**Marina Blvd Street Rehabilitation  
PROJECT NO. 10-150-38-329**

**ADDENDUM NO. 1**

May 26, 2011

| NO.   | REVISIONS | DATE    | INTERSECTION AT VIRGINIA ST AND DONOVAN DR |      |           | APPROVED  |        |       |        |          |     |      |      |

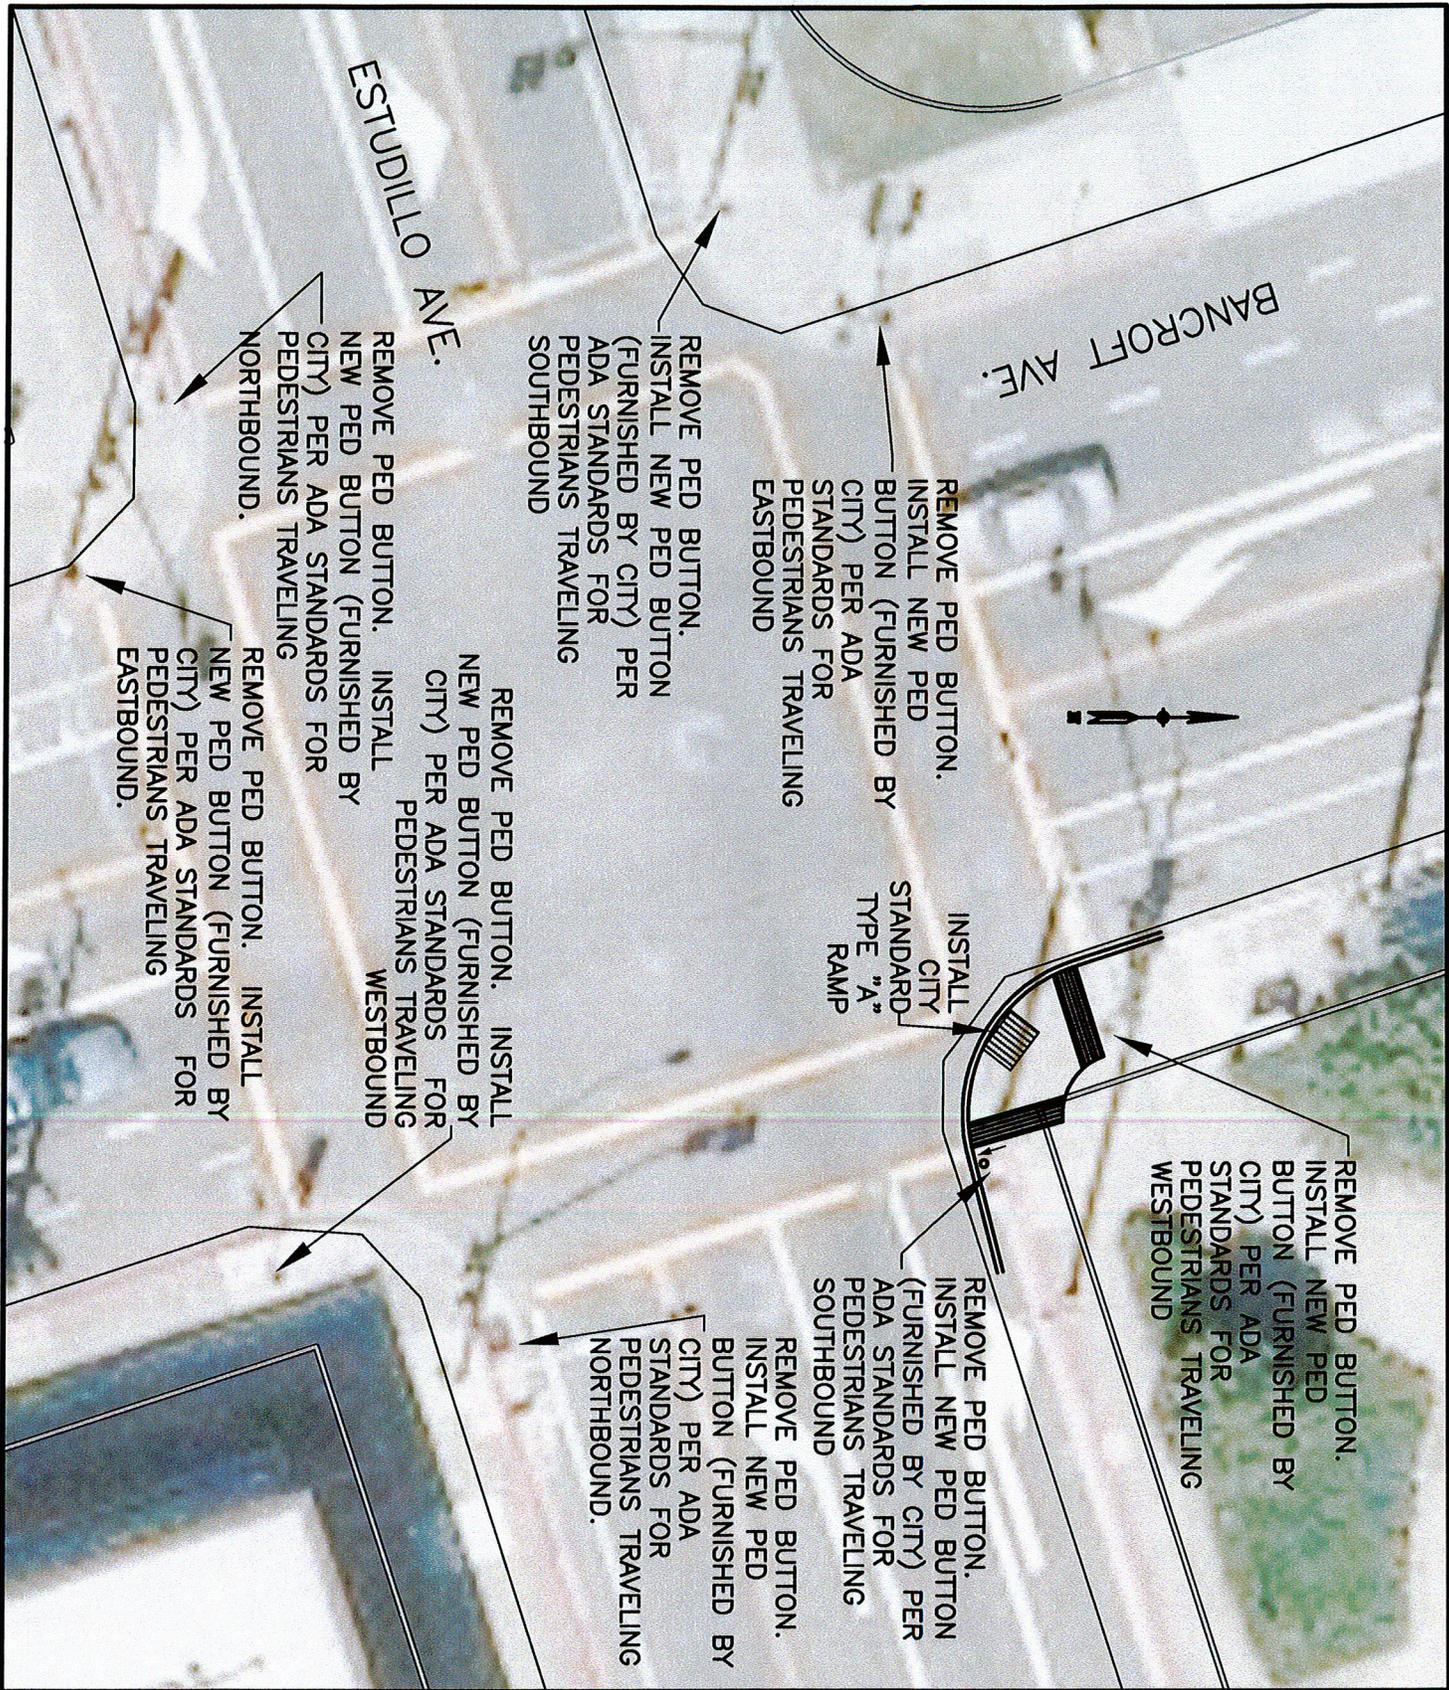
7. Attachment D – Additional Ramp Locations, was added to the Specifications and consists of five pages including the cover sheet.

CONSTRUCT TYPE C RAMP  
PER CITY STD. PLAN NO.  
106B

| ECO | 04-20-06<br>DATE CREATED | SCALE 1:3   | 2 WIRE NAVIGATOR |

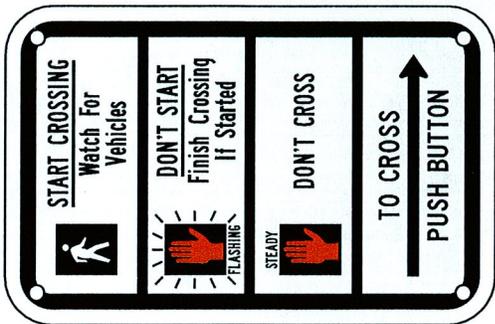
307-10 Pedestrian Push Button – City shall furnish pedestrian push button assemblies to the Contractor. Pedestrian push buttons shall be mounted 42” above the sidewalk.
